Project Name: 126 SE 7th Avenue
Project Location: 126 SE 7th Avenue, Marina Historic District
Request: Certificate of Appropriateness and Variance
Board: Historic Preservation Board
Meeting Date: June 13, 2018

STAFF REPORT

ITEM: 126 SE 7th Avenue, Marina Historic District – Certificate of Appropriateness (2017-274) for two (2) 65 sq. ft. exterior additions, renovations, two new pools, landscaping, hardscaping and Variance (2018-011) to reduce the side interior setback from the required 15' to 7.5'.

A2.0

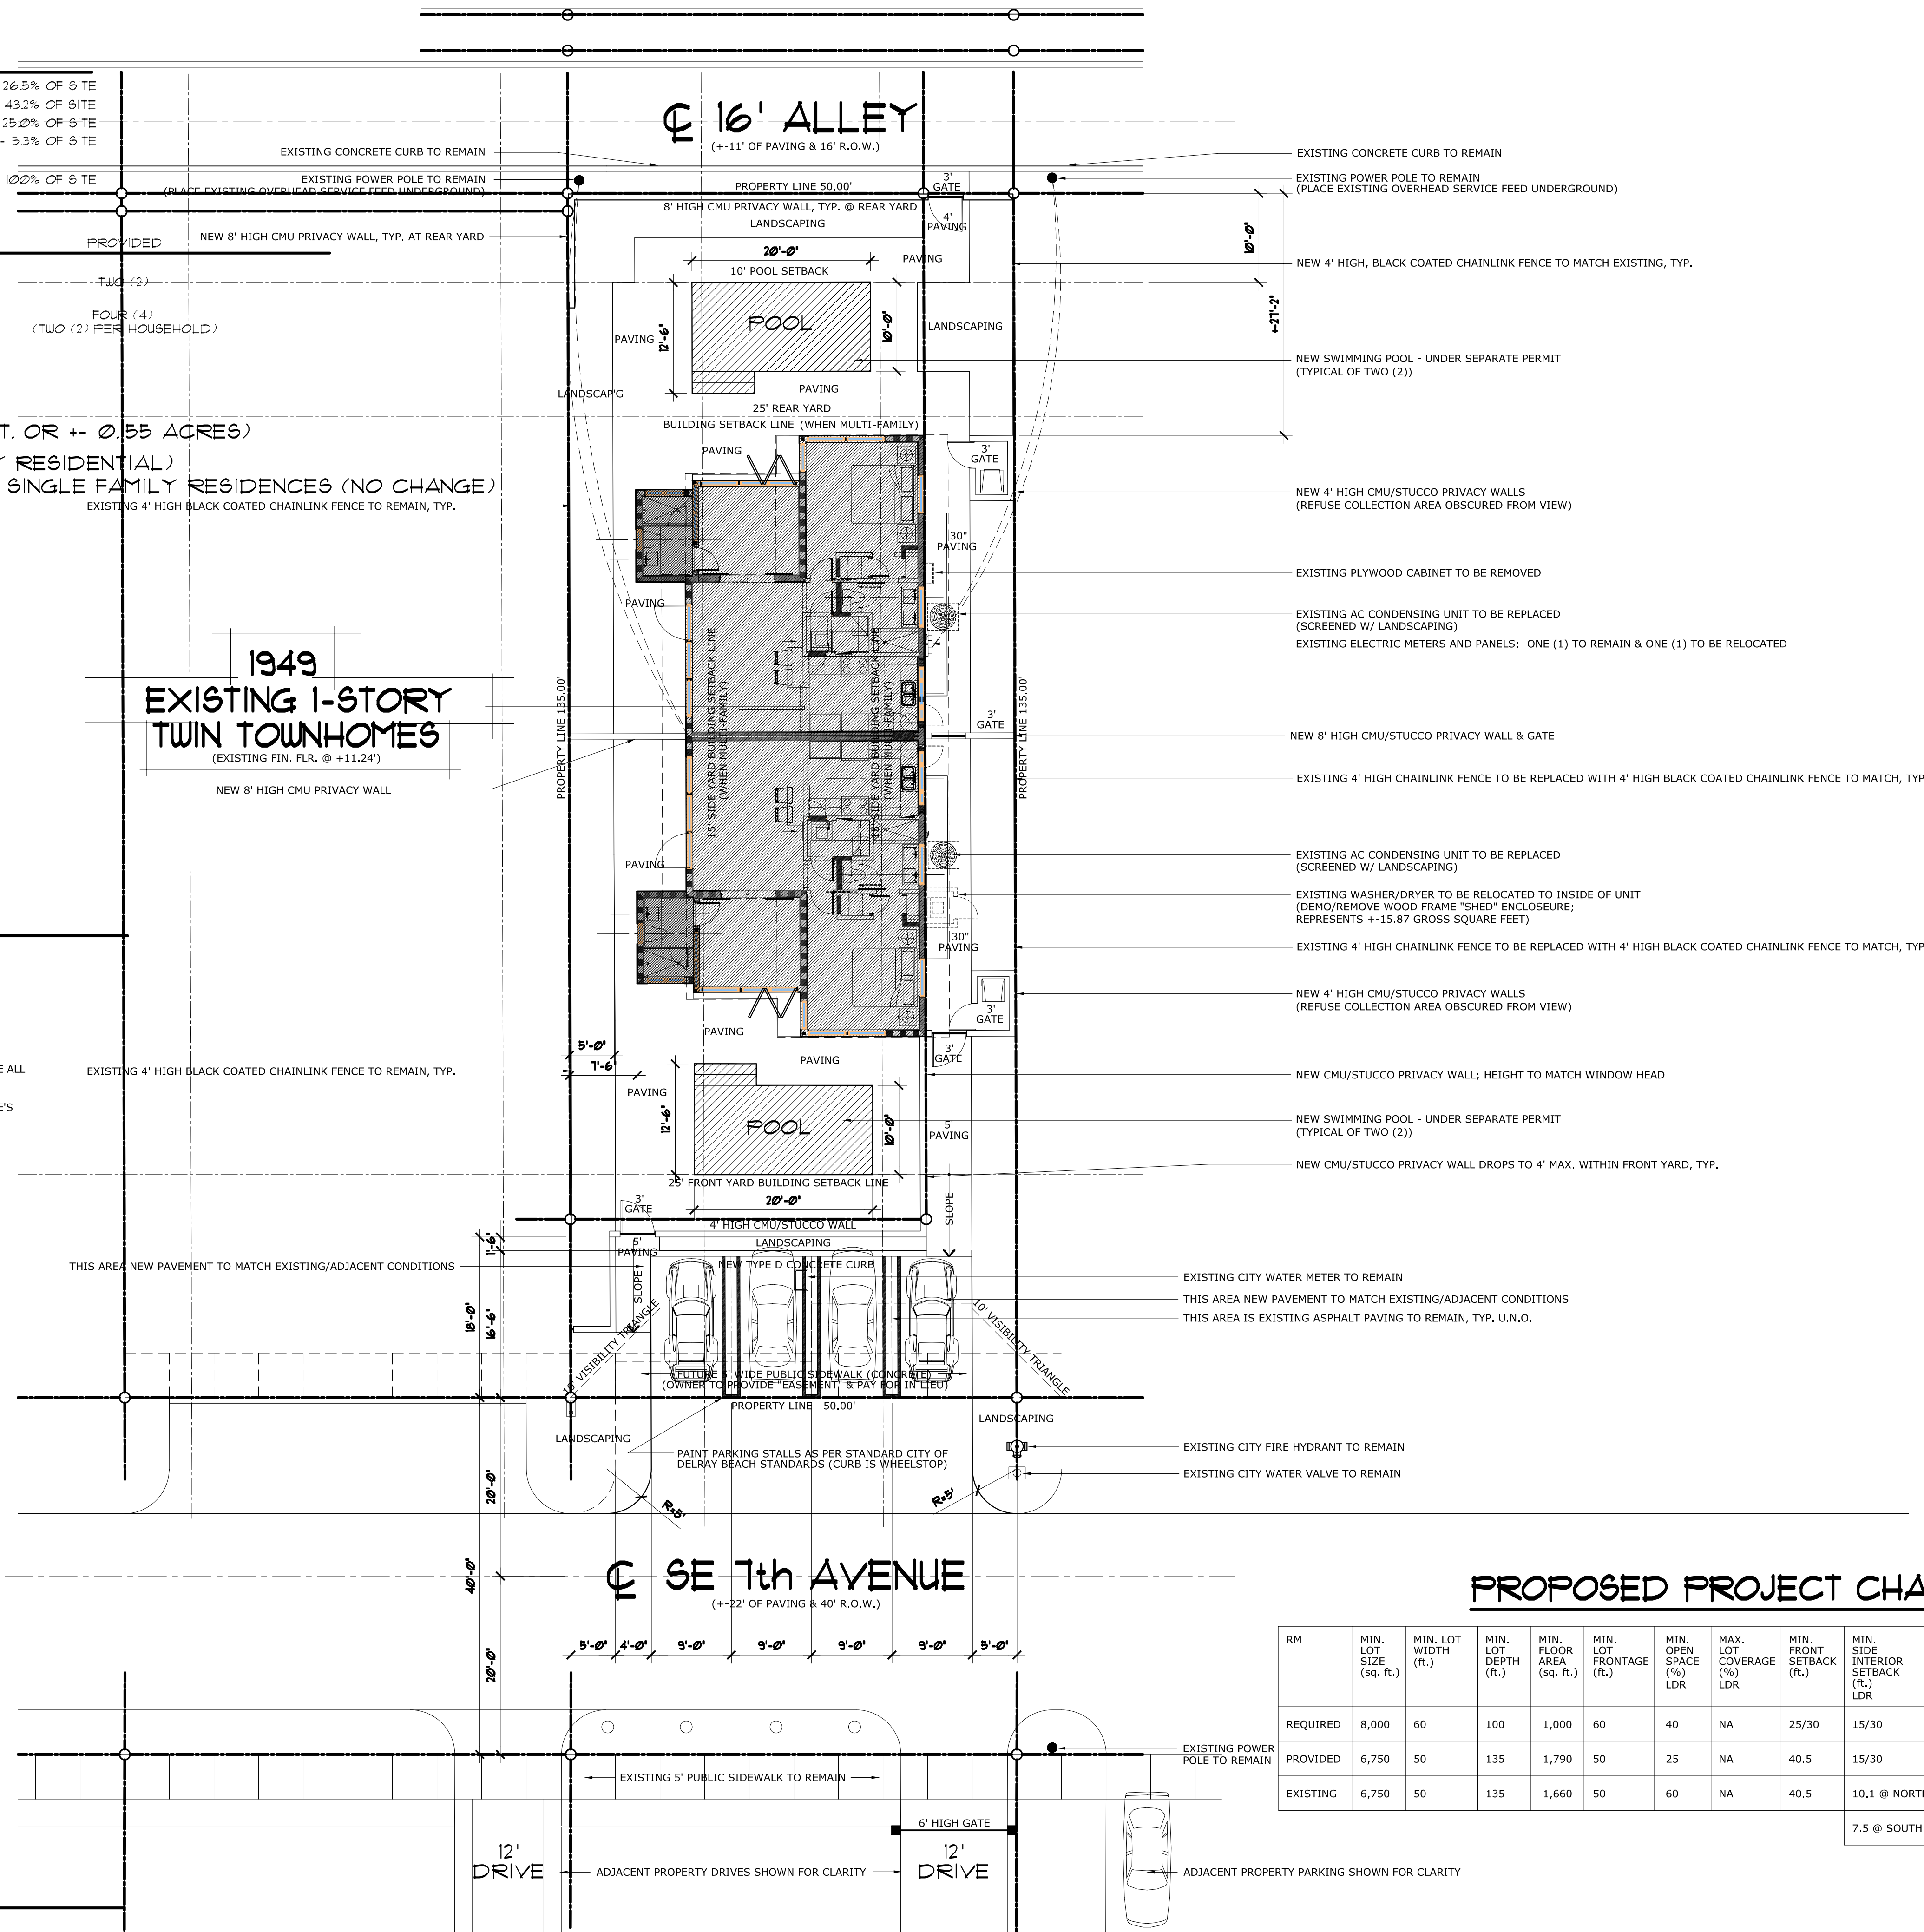
1. That the site plan illustrates the proposed chainlink fence (sheet A2.0).
2. That the note that indicates the new CMU/stucco privacy wall provides the height measurement of the wall (sheet A2.0).

A4 NEW ENTRY (EAST) EXTERIOR ELEVATION

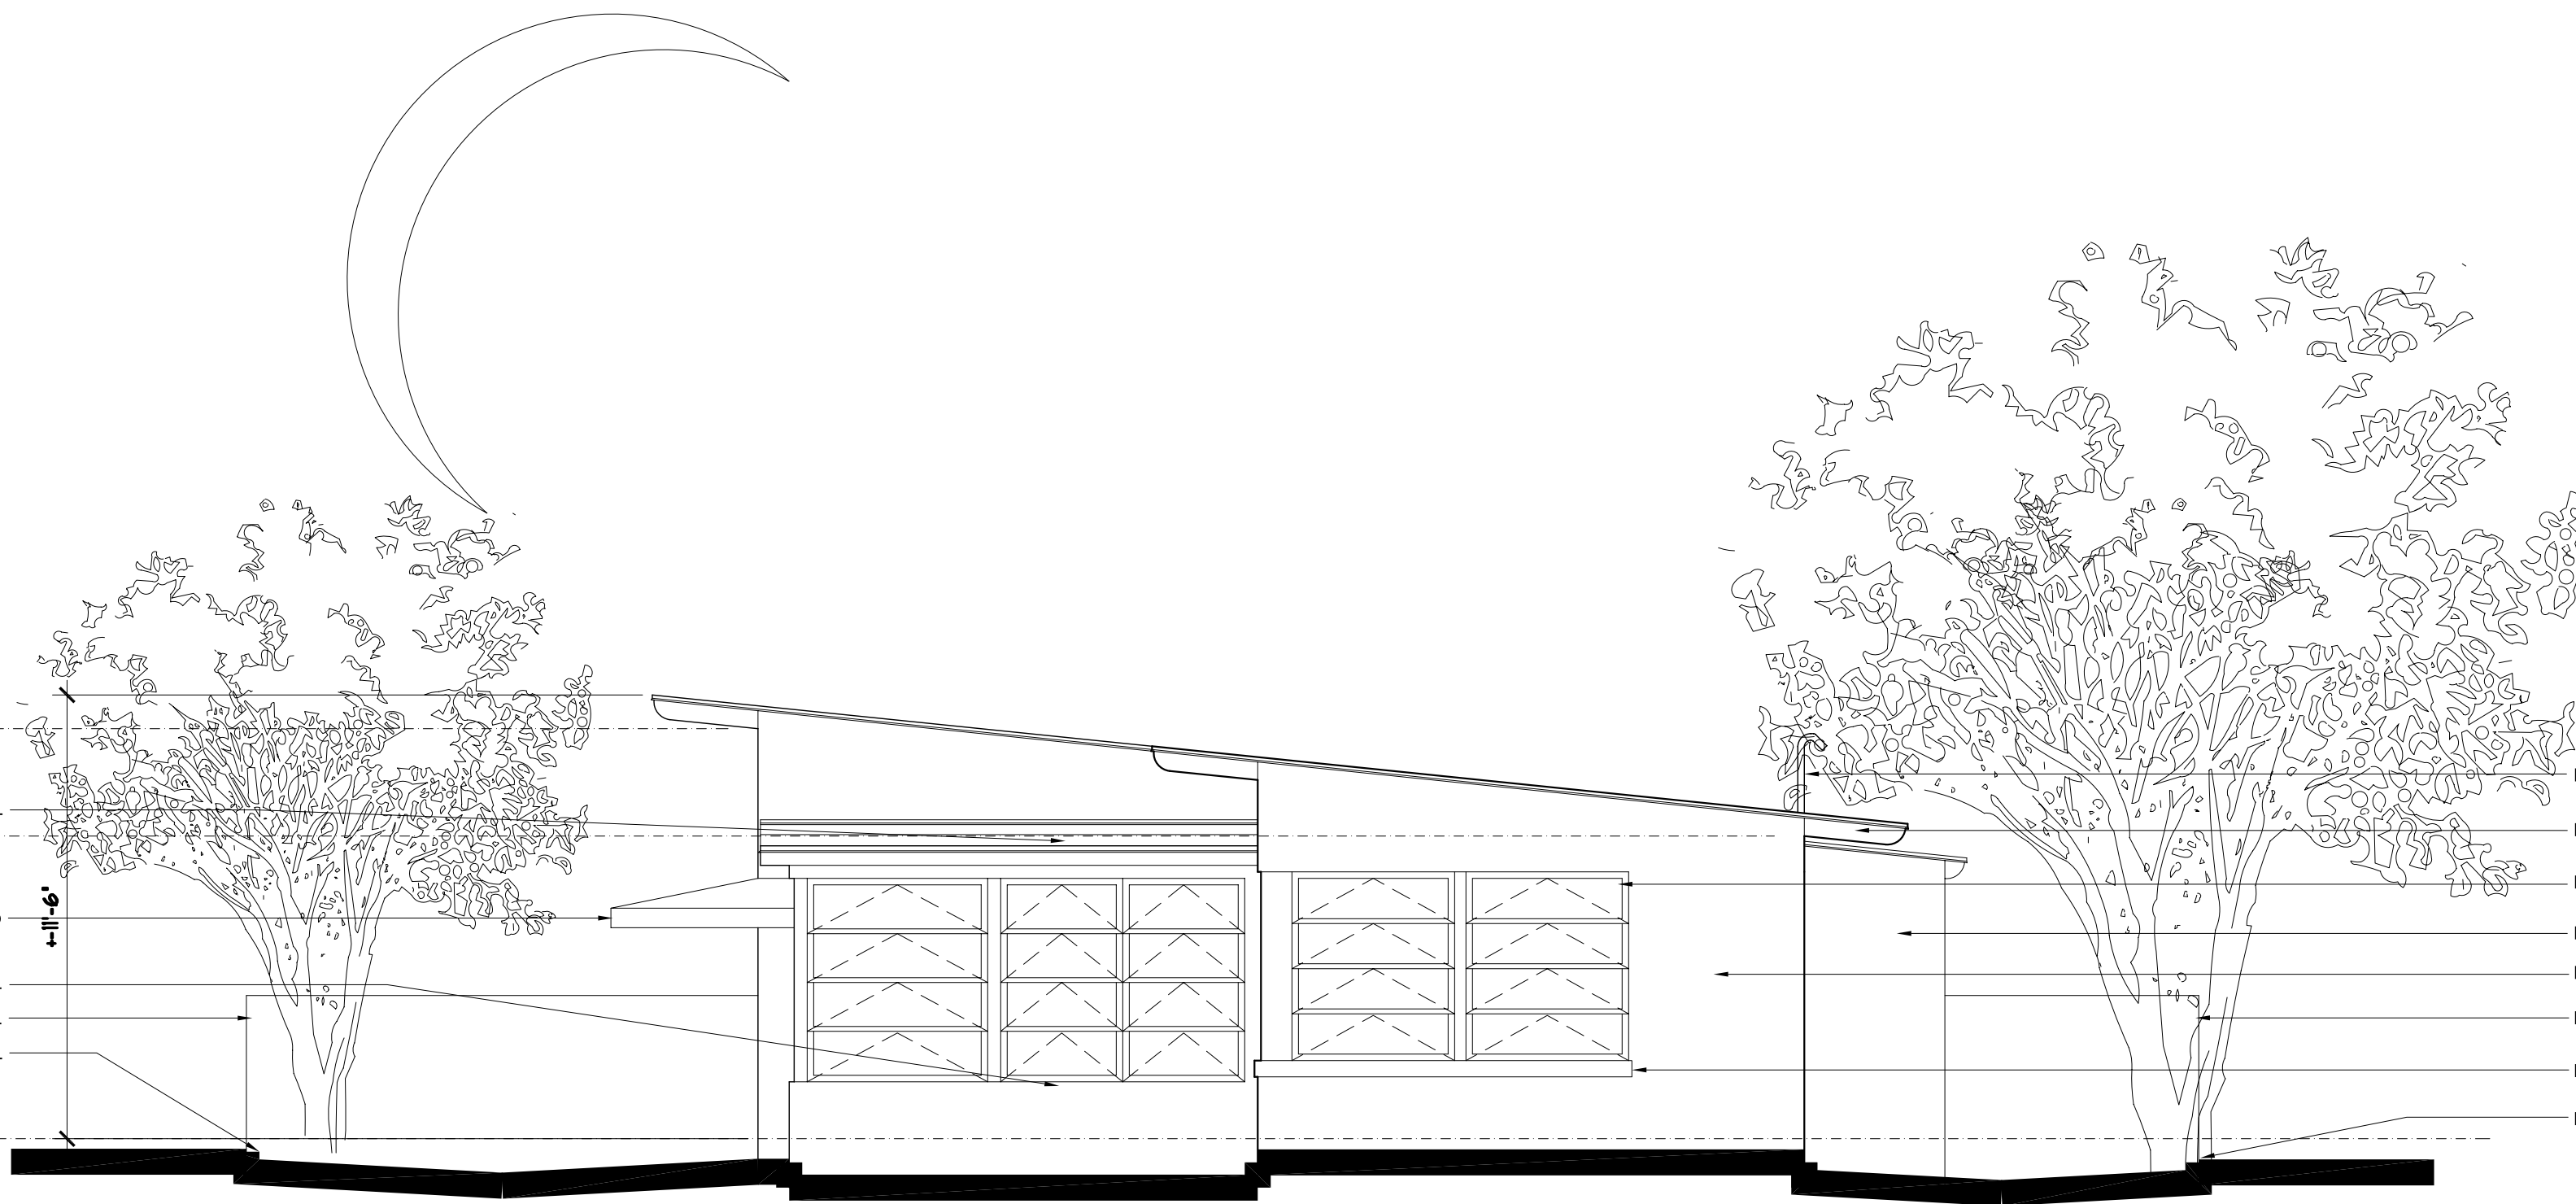
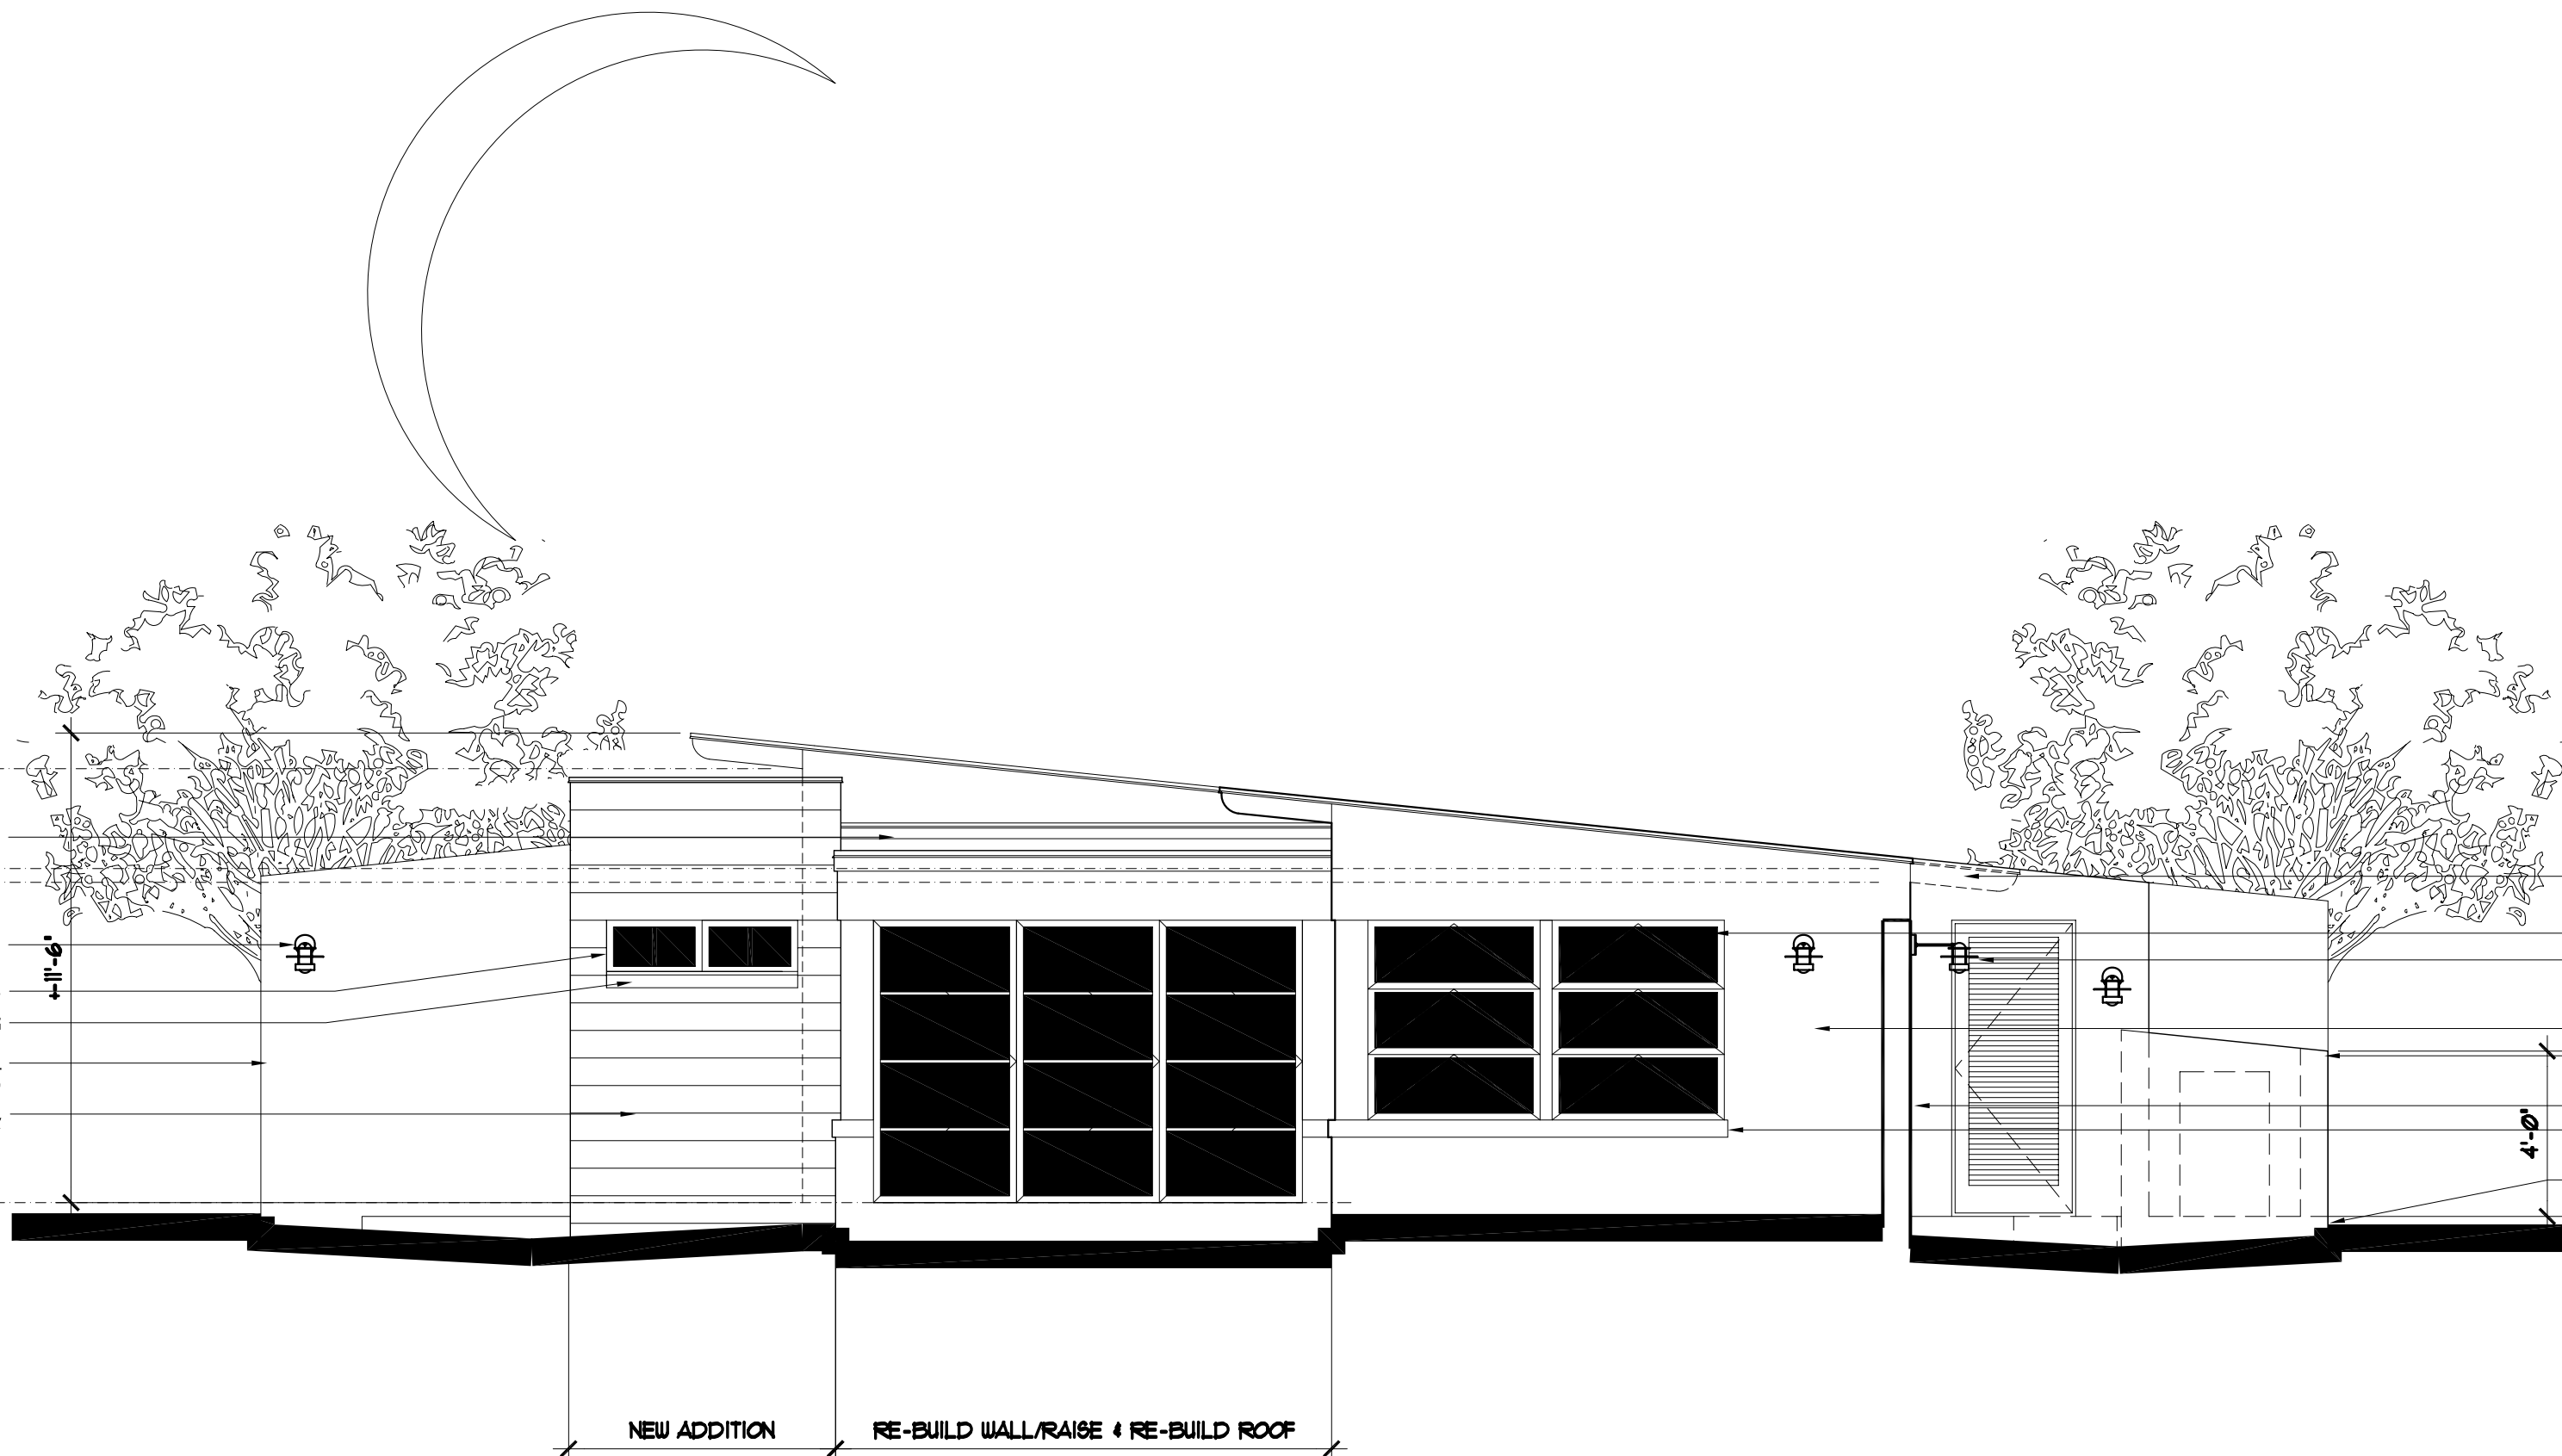
A new 8'-8" high sloped concrete block/stucco privacy wall which is attached to the structure is proposed on the North and South side of the front façade (East Elevation). To meet code requirements, a condition of approval has been added to revise the sloped concrete block/stucco privacy wall to not exceed 8'-0" in height.

1. That the survey's legal description be revised to match the legal description on the property's warranty deed.
2. That the new 8'-8" high sloped concrete block/stucco privacy wall which is attached to the structure be revised to not exceed 8'-0" in height.
